Combination of Integral and Non-Integral
Enhanced Child Restraint Systems under R129
(ECE/TRNS/WP.29/GRSP/2017/XX)

xx.Oct.2017

JASIC

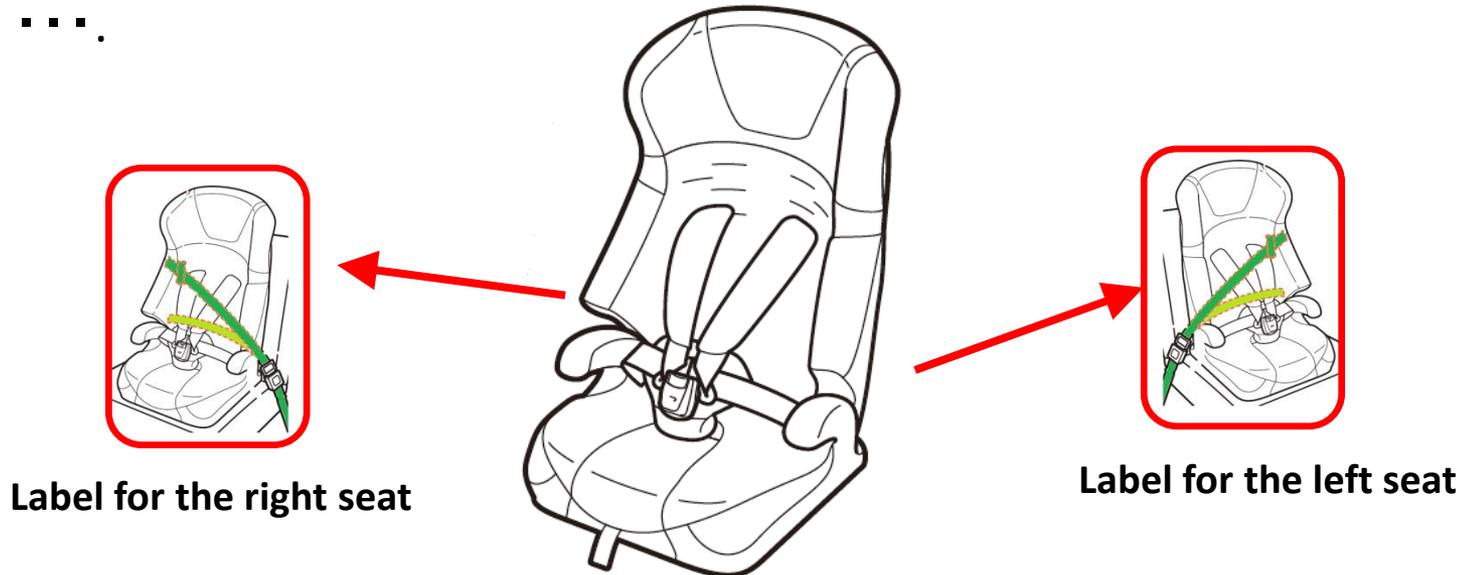
For both Non-Integral ECRS and Integral Belted ECRS, the color specified for the adult belt route marking is green.

- 1) Is combination of Integral Belted and Non-Integral ECRS allowed under paragraph 3.2.2.?
- 2) If the answer to 1) is yes, it may cause confusion to consumers, as both Integral Belted ECRS (4.6.2.) and Non-Integral ECRS (4.6.3.) are required to have a green belt route marking even though the route differs between these ECRS.
- 3) New icons are required as “additional markings” (4.12.). However, if they are to be placed on both sides of the CRS, they will be laterally inverted. How should they be marked?

Belt routing icon to be used on or near belt guiders

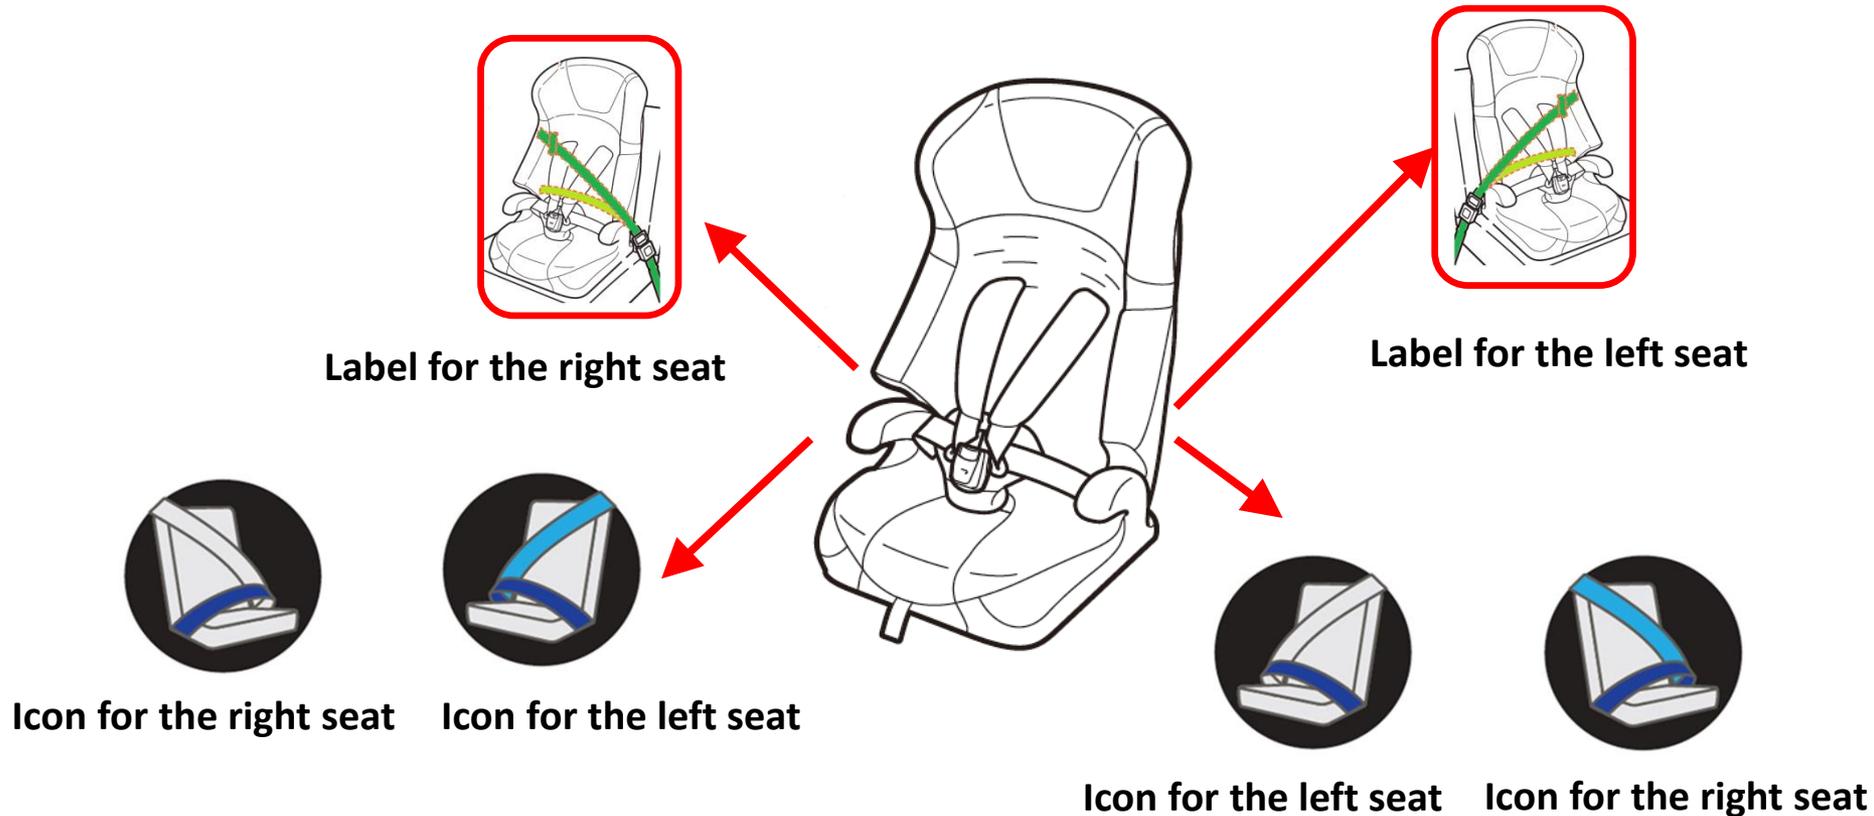
In addition, new icons will be required for the ECRS belt guide area.

If two CRS are to be installed, one on each side of the vehicle, the shoulder belt path and lap belt path in the belt guide area will be laterally inverted.

Would not this confuse consumers?
